Our ref: 50589-LT01-A
Your ref: DEV2022/1325
Contact: James Goodman

**Response to Further Issues – Application Number DEV2022/1325
Proposed Mixed Use Development
16 Nexus Way (Lot 3A Corner of Knowledge Street and Bonner Street), Southport
(Part Lot 9 on SP275512)**

Reference is made to a Further Issues letter dated 11 October 2022 from Economic Development Queensland (EDQ) in relation to the abovementioned development application. The purpose of this letter is to provide a response to 'Transport Management' related items and 'Waste Management' items of the Further Issues letter.

Project Architect/Designer	Drawn By	Date Drawn
MK	CZ	
Checked	Date Checked	Scale @ A1
-		1 : 100
Drawing No.	Revision	
6140.1S.02.002	P

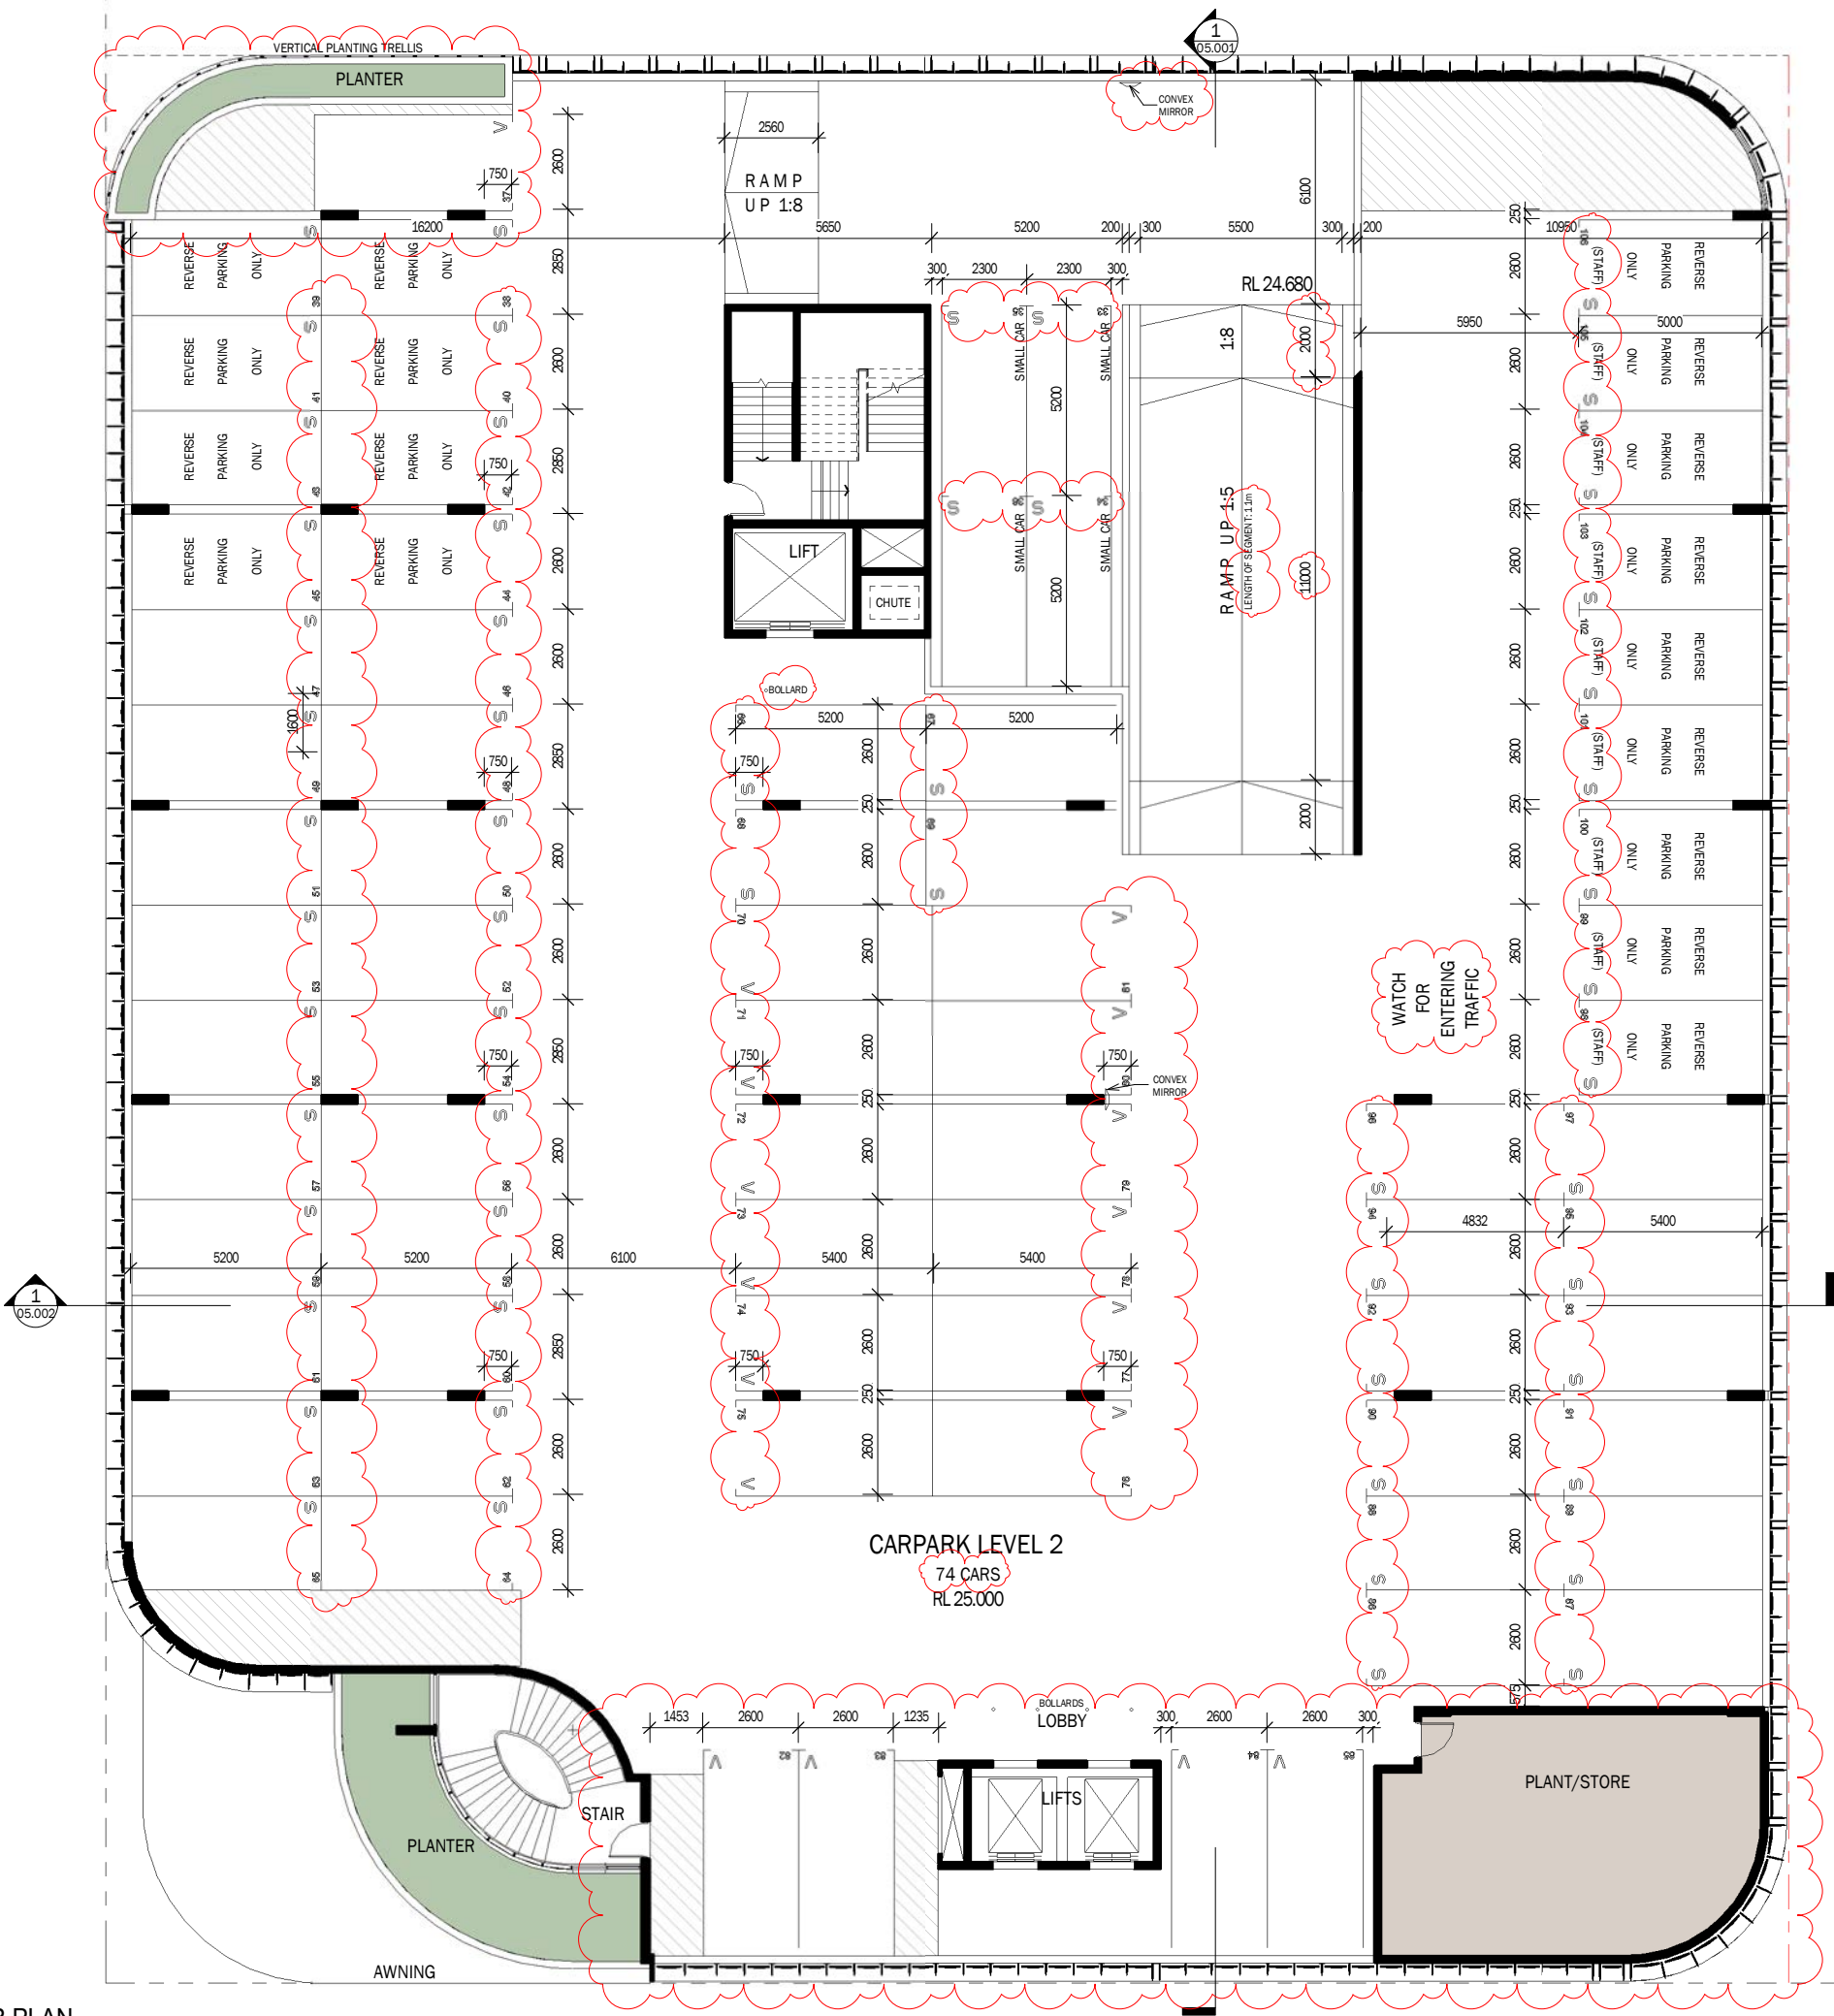
- a. Table 3.2.2 shows a general waste calculation for the Level 4 Food and drink outlet of 4,116L when it should be 9,055L.
- b. The total for the site is 36,113L / week, rather than the 31,117L.
- c. The proposed 6 x 2,000L general bins and 5 x 2,000L recycling bins, however the plans show 9 x 2,000L bins and 2 x 1,000L bins

29. Amend the architectural plans to show the bins as nominated in the WMP.

30. Label general and recycling bins (include colours to differentiate or a G / R) for each bin.

The correct waste generation rate for the food and drink outlet land use comprises 300L per 100m² not 660L per 100m². The waste management plan has been amended to include the correct rate as provided in **Attachment D**. In addition, the plans of development have been updated to show 6 x 2,000L general bins and 5 x 2,000L recycling bins within the refuse storage room on Level 1 (**Attachment A**).

The plans of development have been updated to reflect the quantity of bulk bins specified in Geleon *Waste Management Plan 50589-RP02-B*. Updated plans of development reflecting this change are included as **Attachment A** to this letter.

The plans of development have been updated to include colour differentiations for the general and recycling waste bulk bins located in the refuse storage room on Level 1. The general waste bulk bins are shown as red, and the recycling waste bulk bins are shown as yellow. Updated plans of development reflecting this change are included as **Attachment A** to this letter.

Project Architect/Designer	Drawn By	Date Drawn
MK	CZ	
Checked	Date Checked	Scale @ A1
-		1:100
Drawing No.	Revision	
6140.1S.02.003	N

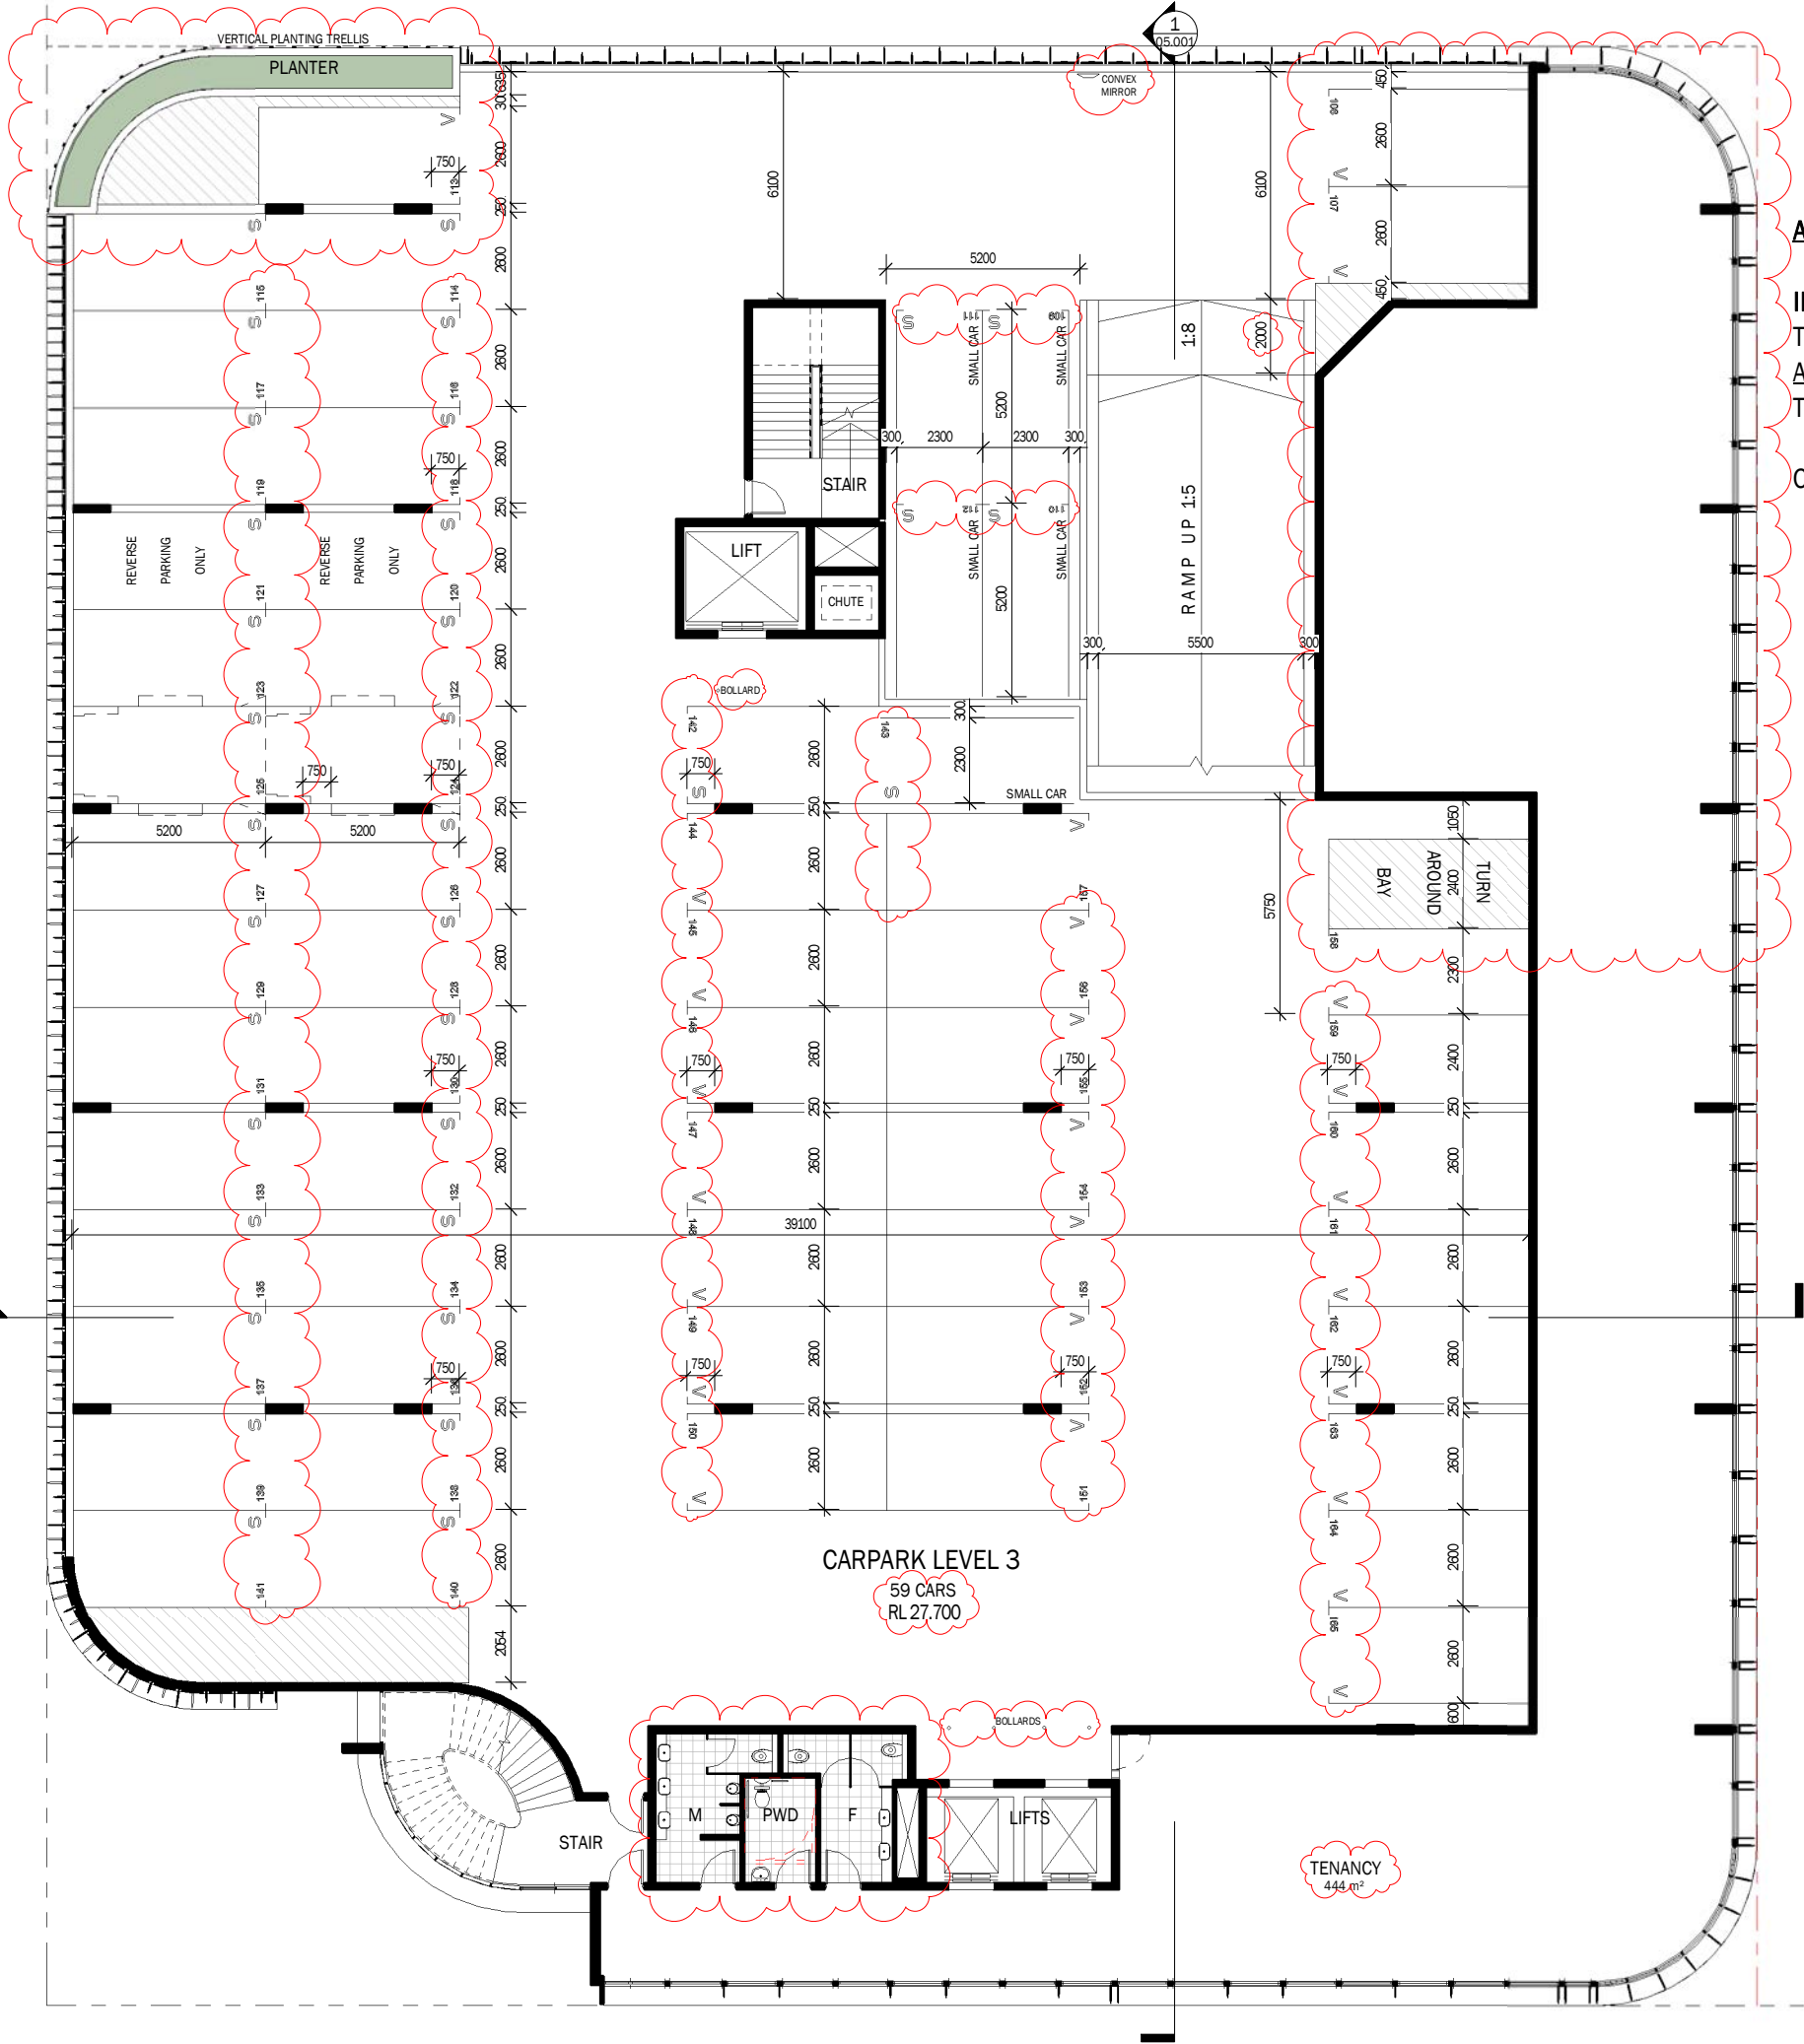
- a. Demonstrate a strategy to mitigate the risk associated with the proposed staff parking area and the blind aisle. The current arrangement creates a risk of collision for vehicles exiting the premises and turning to/from the ramp.

To mitigate the risk of a collision associated with the staff parking area on Podium Level 2, a convex mirror is proposed opposite the access into these spaces as well as pavement marking alerting drivers to 'watch for entering traffic'. These mitigation measures will improve the awareness and visibility for vehicles exiting the staff parking area on Podium Level 2.
